Town of Hilton Head Island
Design Review Board Meeting
Tuesday, November 8, 2022 – 2:30 p.m.
AGENDA

PROJECT NAME: Nunzio Restaurant

DRB#: DRB-002303-2022

DESIGN TEAM/DRB COMMENT SHEET

Image 4: New trellis and lattice wall

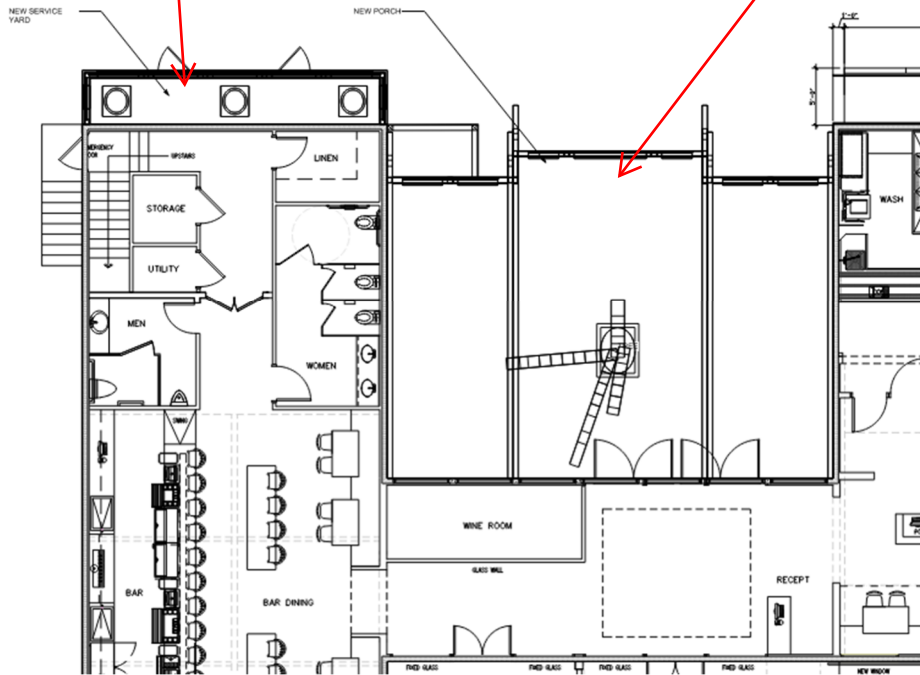
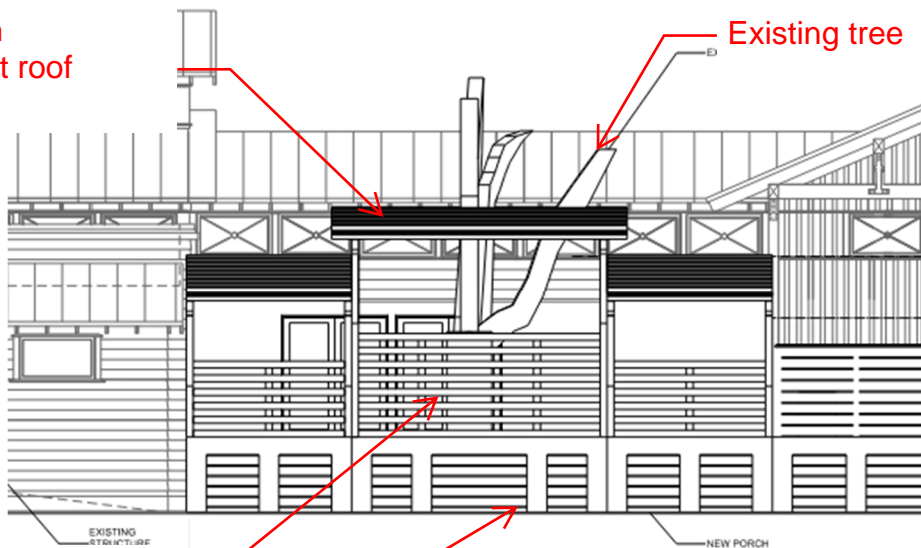
- e. Consider attaching the translucent roof material under the trellis to mitigate the appearance of the material.
 2. The DRB had concerns about the trellis structure:

- a. How does the trellis work around the tree?
 - b. The trellis columns are too congested with multiple brackets, beam heights and screen heights.
 - c. Consider one column where there are two, side by side.

- d. The porch / trellis structure should be more sophisticated. The DRB is concerned the structure looks inexpensive and DIY.
 3. Provide an elevation of the interior porch wall to include all fixtures, windows, and doors.

SHEET TITLE
TREE REMOVAL
PLAN

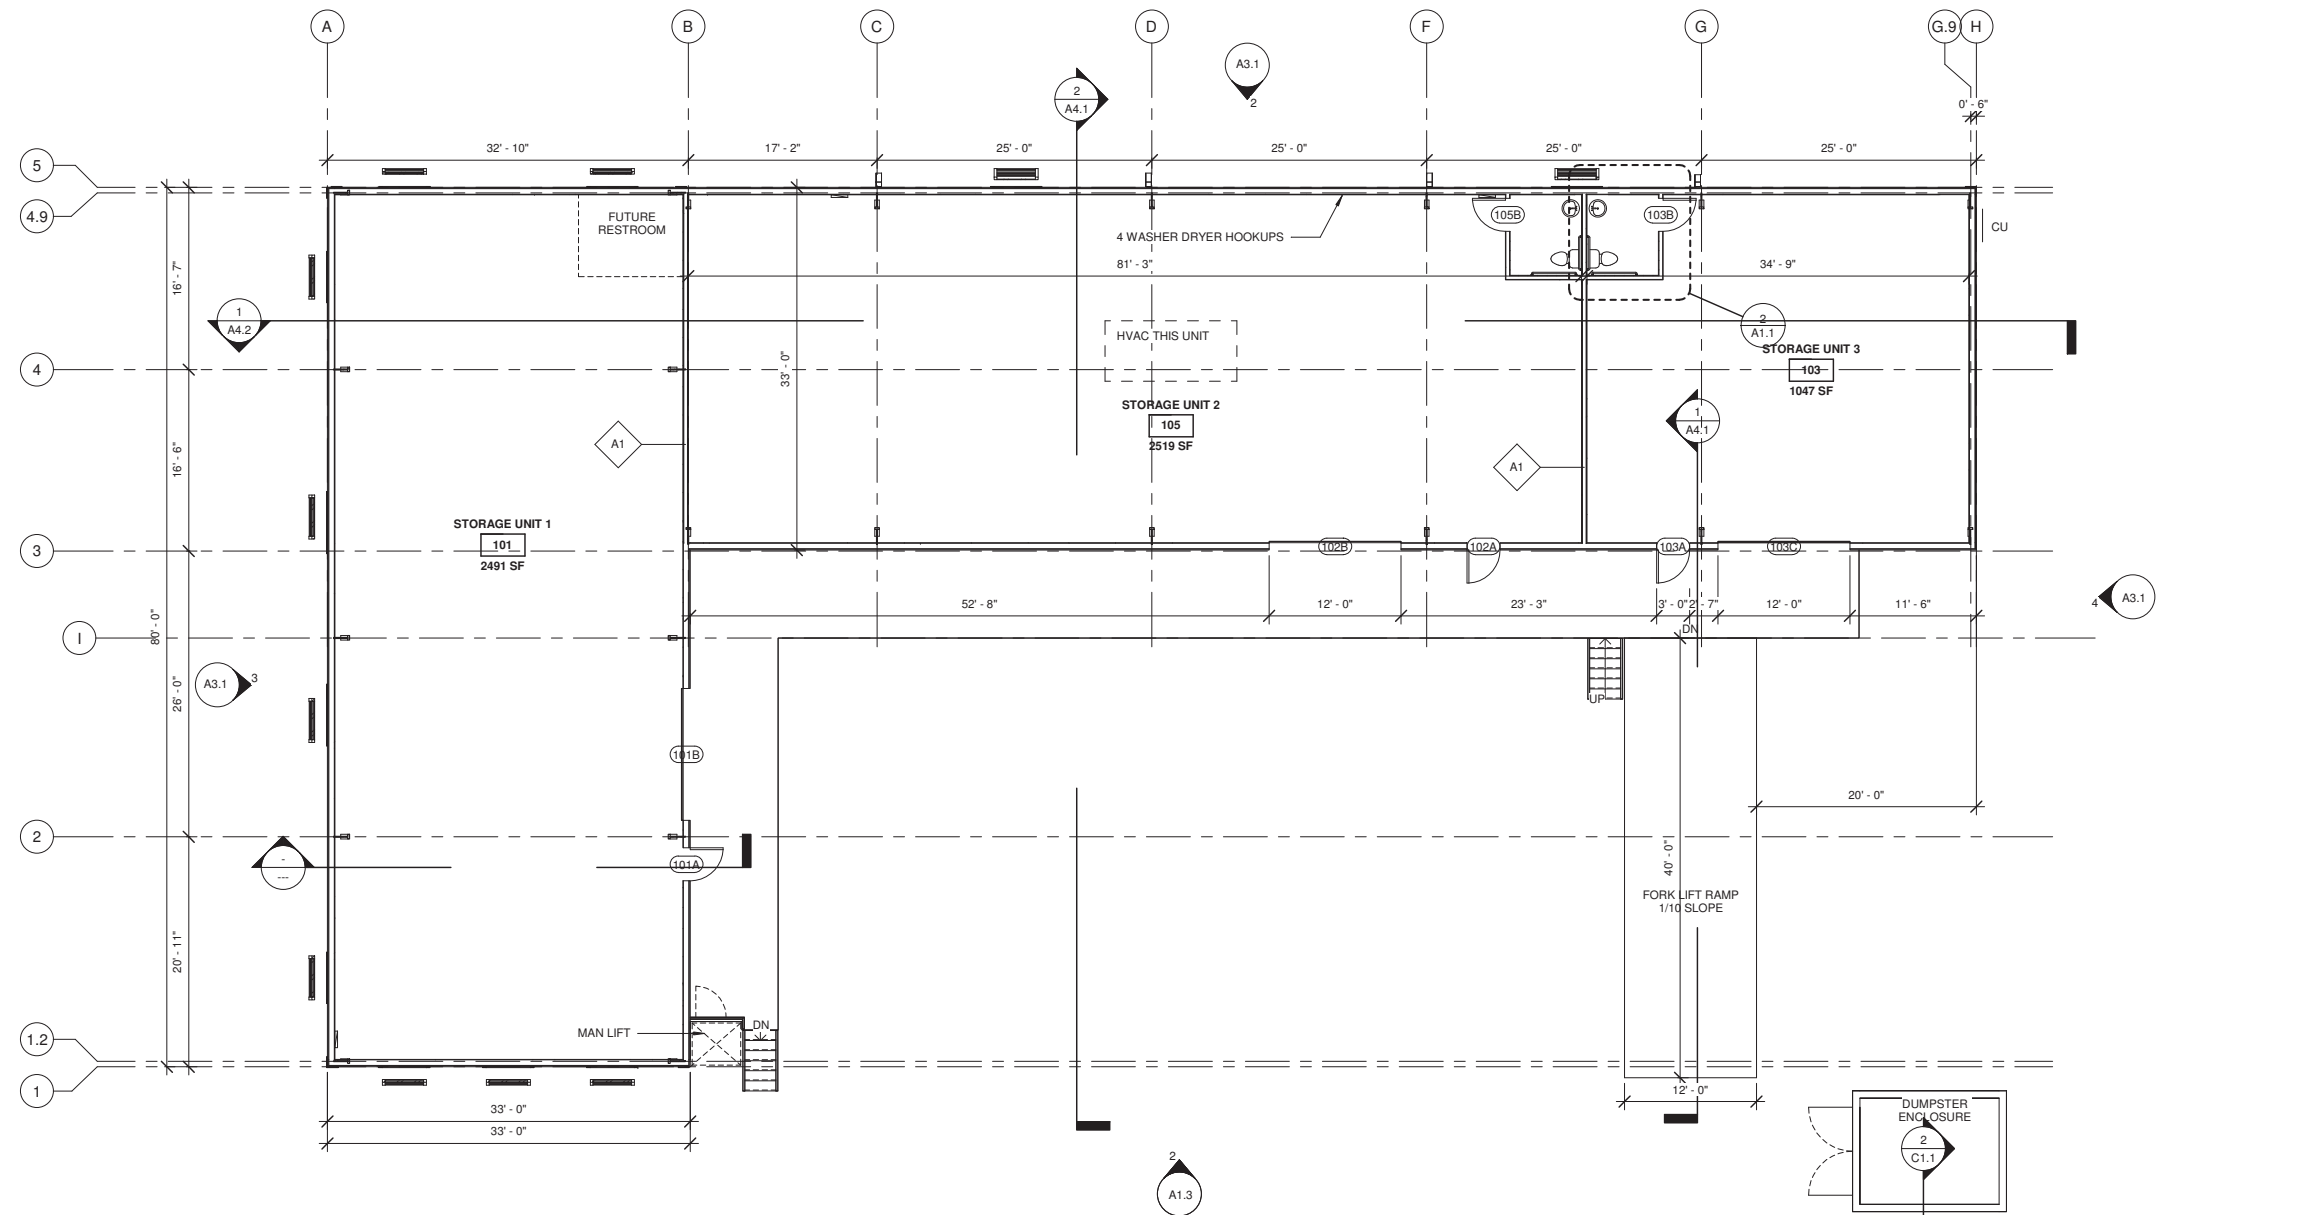
1. Add the following to the Tree Removal Plan:
 - a. Show tree protection fence the entire length of the street buffer,
 - b. Add silt fence to the Plan,

- c. Add note to the buffer that “understory growth is to be preserved”.
2. Revise the dumpster enclosure detail to include:
 - a. A gate detail that matches the screen,

is a major component of Island Character.” In order to proper protect this buffer the following should be added to the Tree Removal Plan C1.2: <ol style="list-style-type: none"> 1. Tree protection fence the entire length of the buffer. 2. Silt fence should be shown. 3. Add note to the buffer that “understory growth to be preserved”.
Dimensioned Details and of Sections	<input type="checkbox"/>	<input type="checkbox"/>	<input type="checkbox"/>	DG, page 32 “Enclosures should be designed to allow adequate air flow as needed but not allow visibility into the enclosure.” Provide a detail for the, dumpster gate.

2 BACK ELEVATION
A3.1 1/8" = 1'-0"

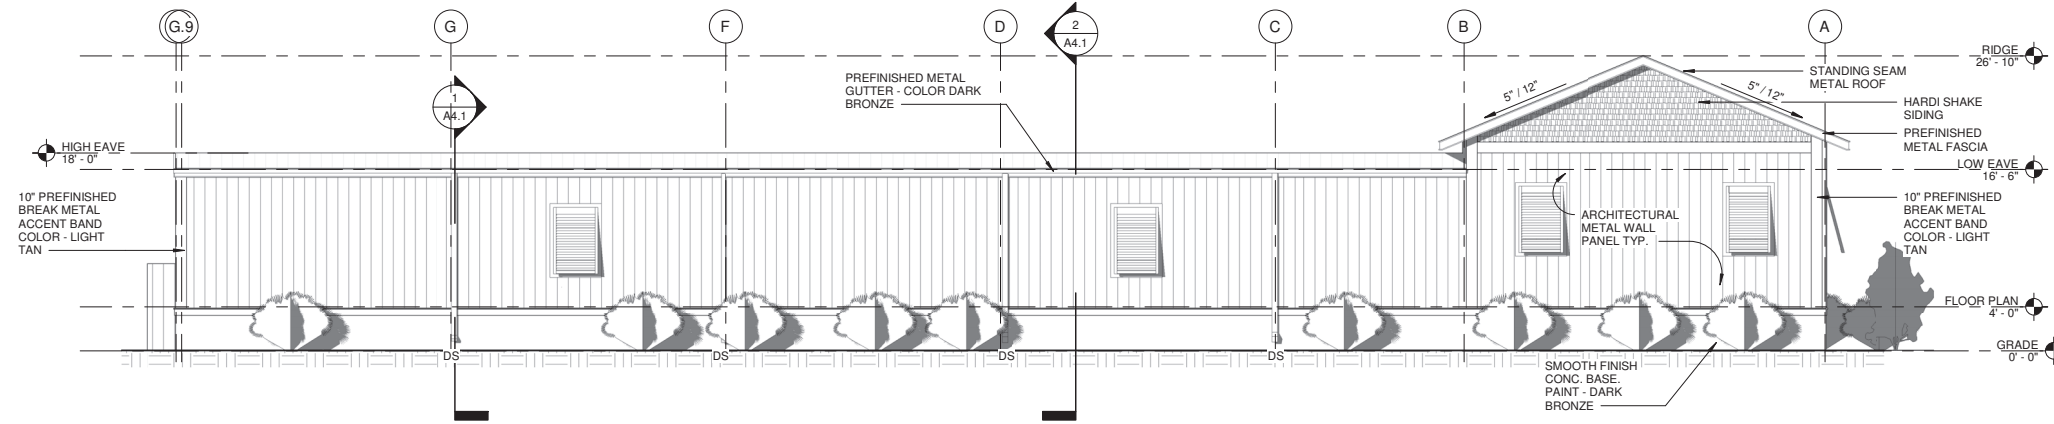
- b. Specify the service yard screen to be painted SW 6153 Superior Bronze.
3. Add a shutter between each of the down spouts on the “Back Elevation” Detail 2/A3.1. (total 2 additional shutters)
